SPRINGS AT WATERVIEW - AMENDED STORM

GRINNELL DITCH NORTH - PLAN / PROFILE

GRINNELL DITCH SOUTH PROFILE

STORM B PROFILE

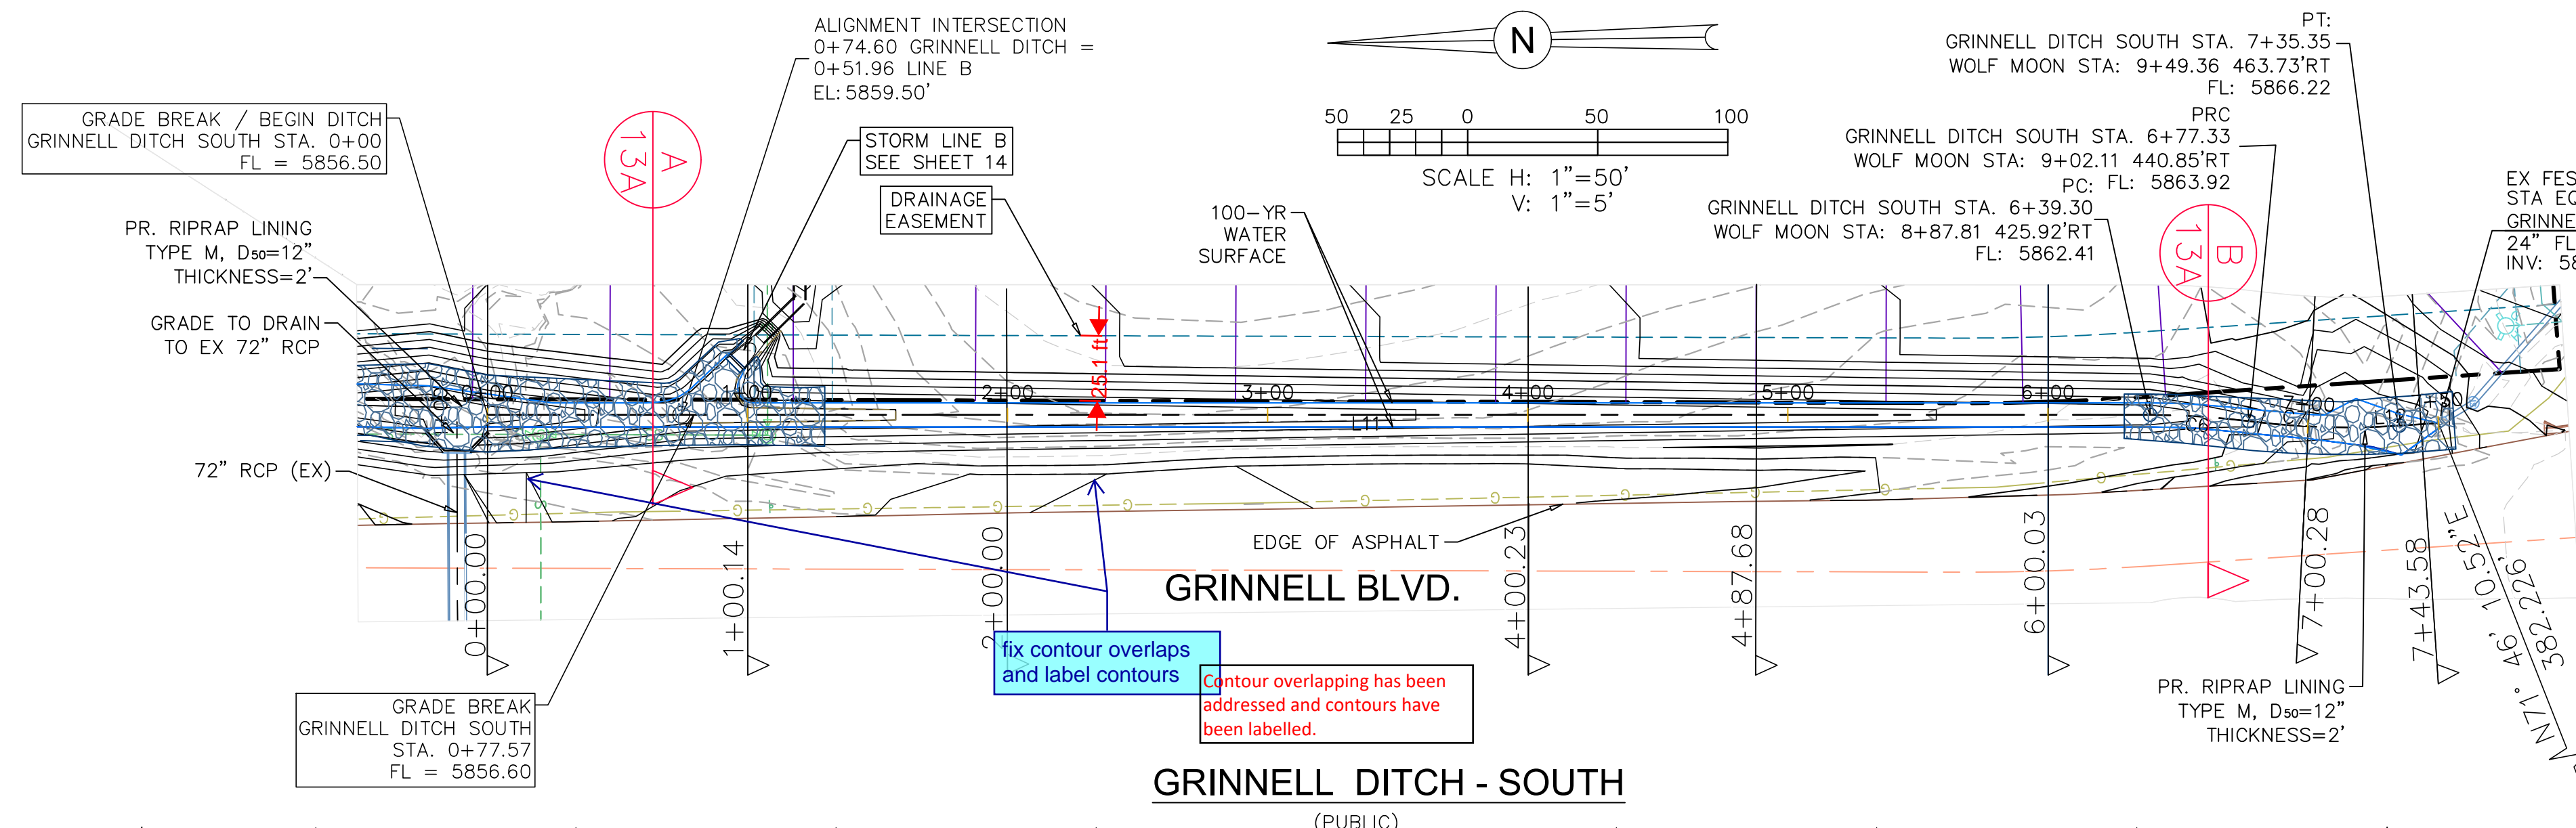
Provide delta angle

See previous page for comments regarding the cross sections

The horizontal control table has been modified to include delta angles for the curves.

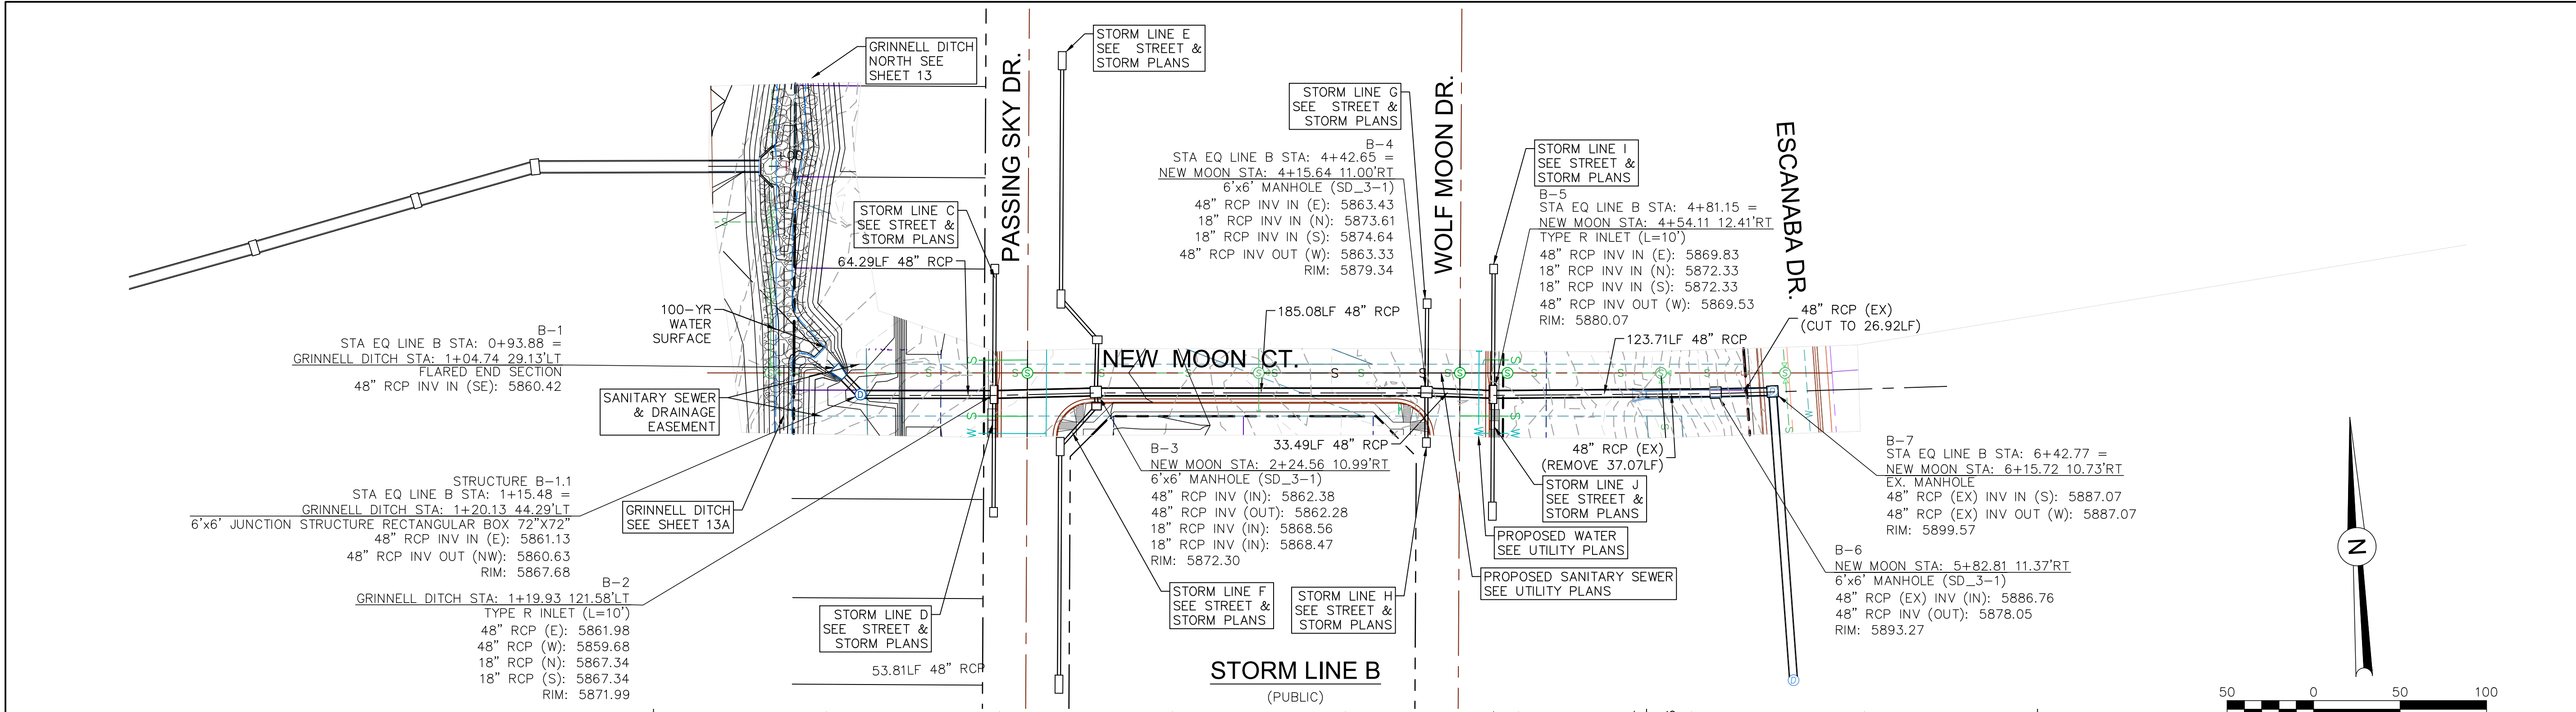
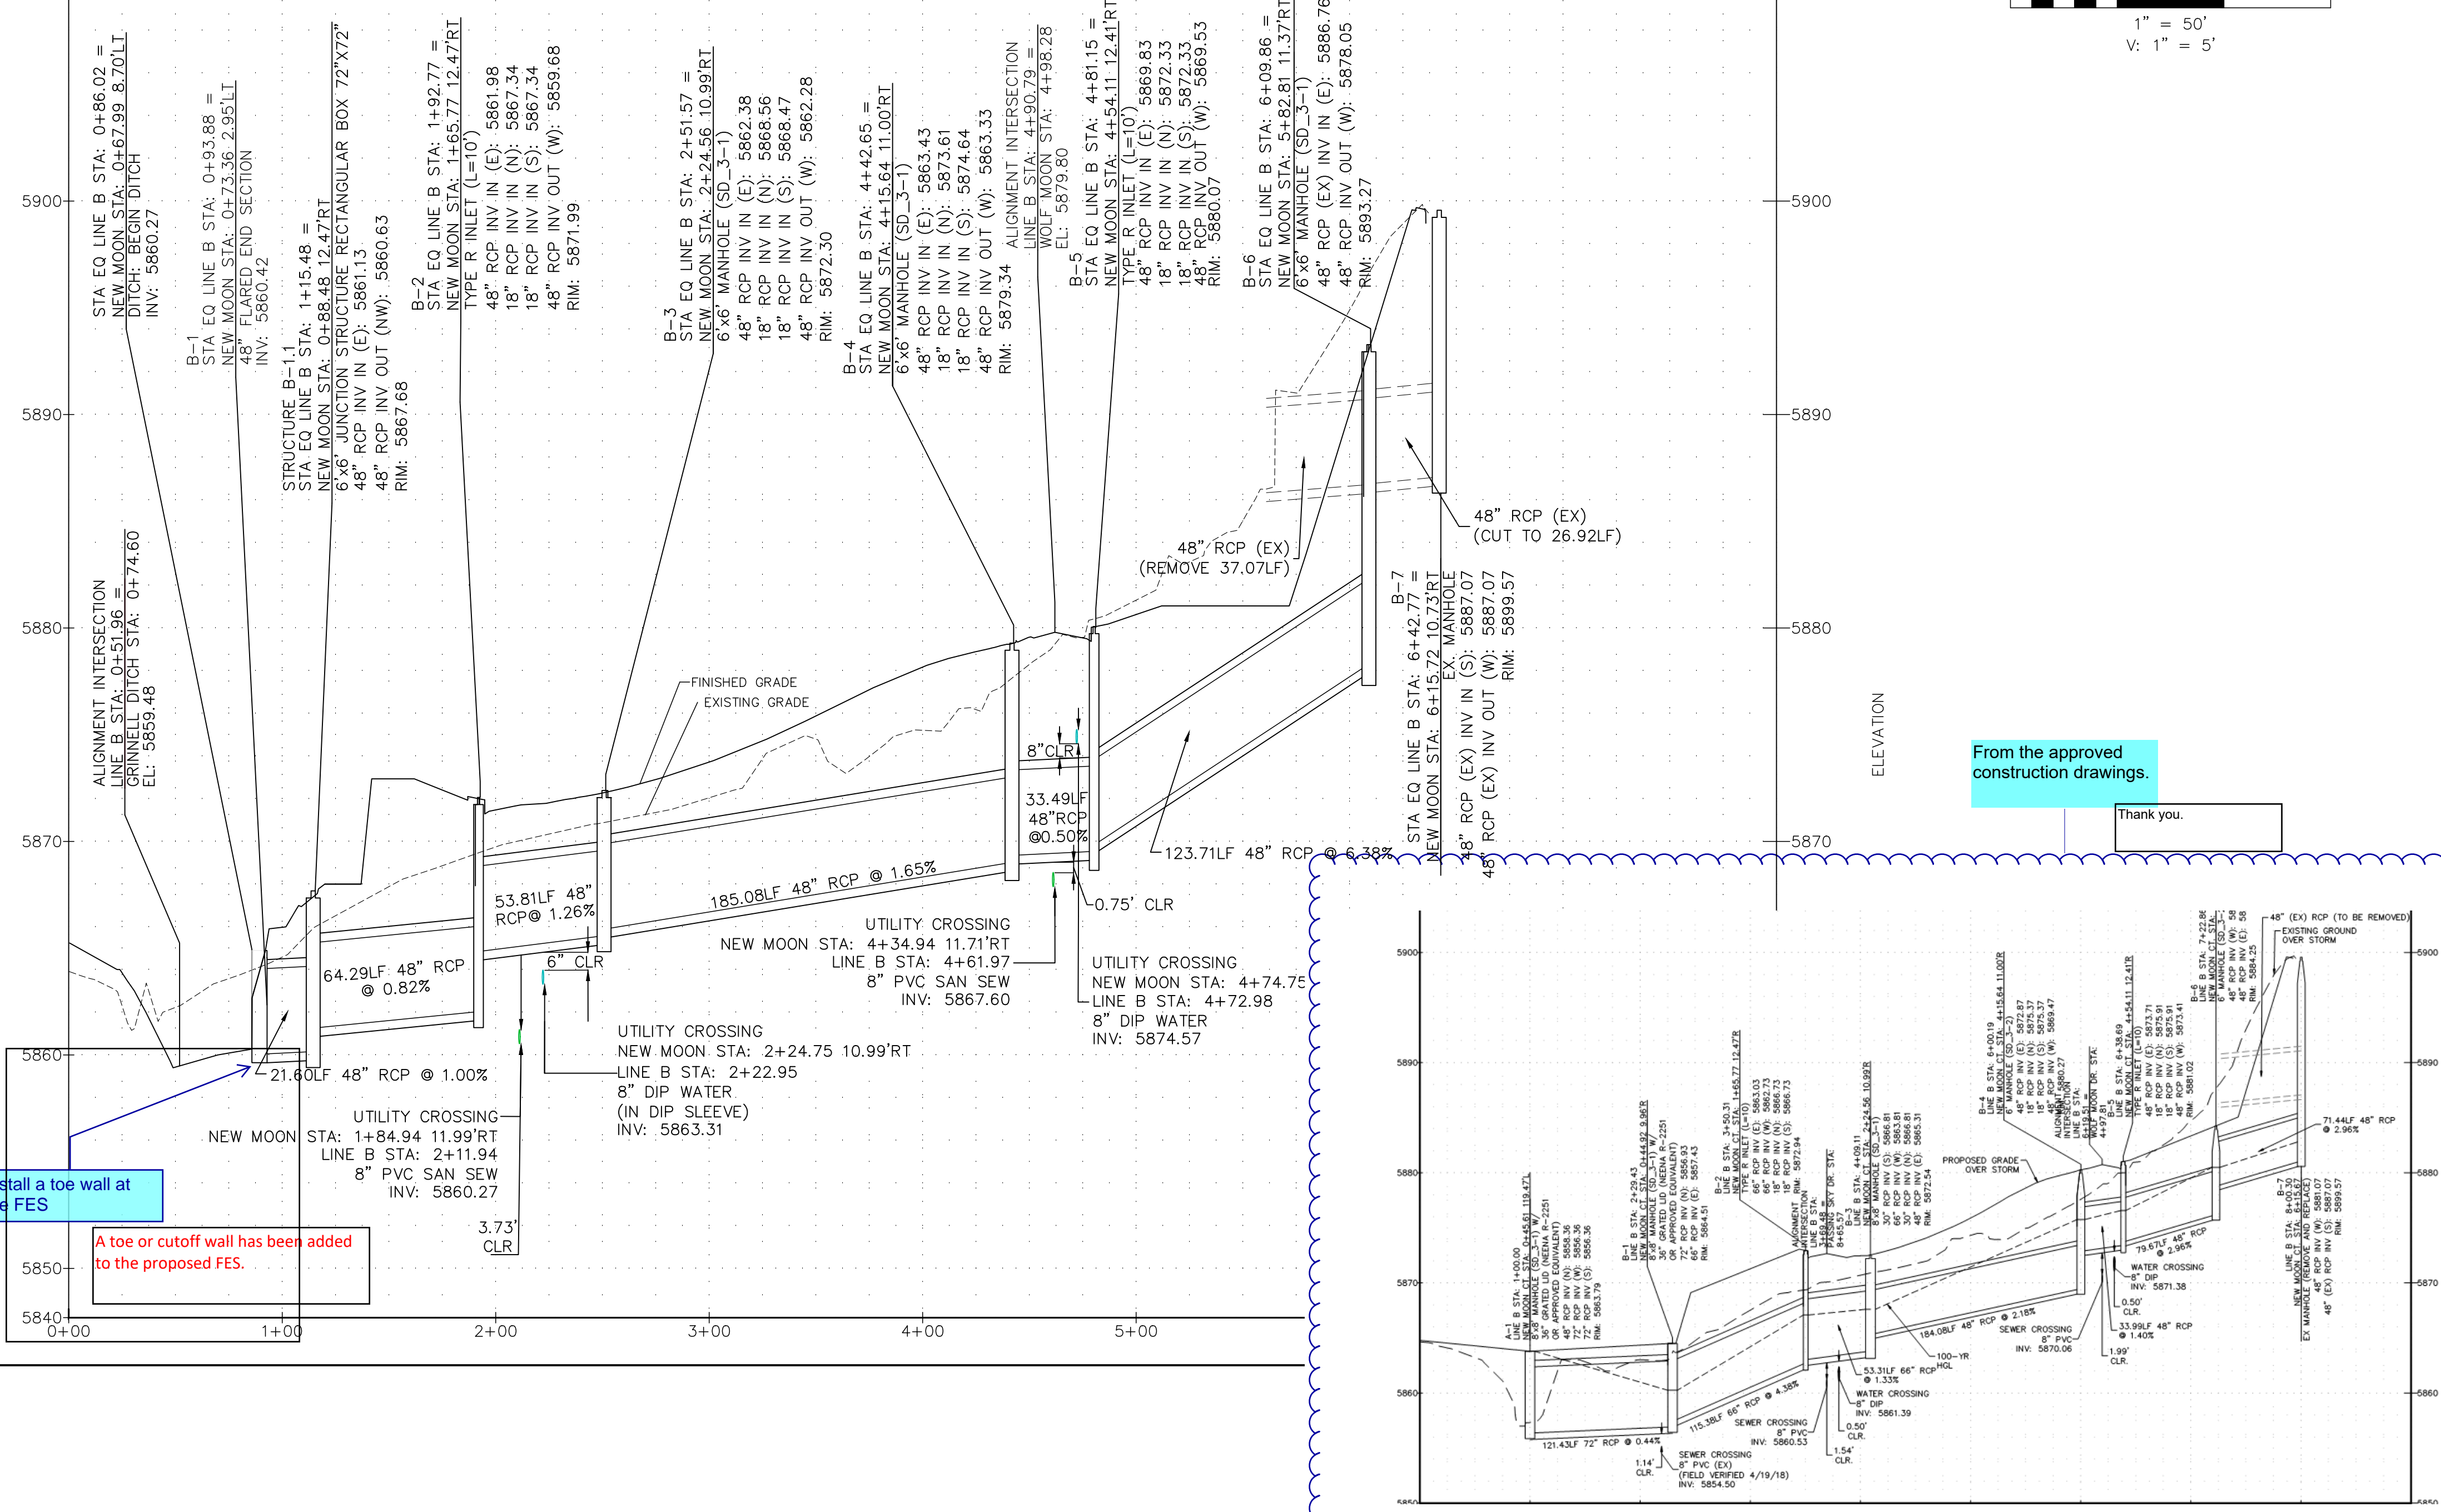
Draw revision cloud around the elements that are revised from the originally approved design.

Per the first review comments, the drainage letter needs address the changes and show the updated calculations. (See snippet below from the review 1 of the drainage letter)

This entire stormline B is completely altered from the originally approved report. Update the drainage letter to have the supporting narrative and calculations.

Install a toe wall at the FES

Similar comment for the proposed storm. Narrative should be specific to the amendment only. Describing which system is being revised, what is proposed, and explaining the results of the calculations.

Remove any hydraulic analysis not pertinent to this report.

A toe or cutoff wall has been added to the proposed FES.
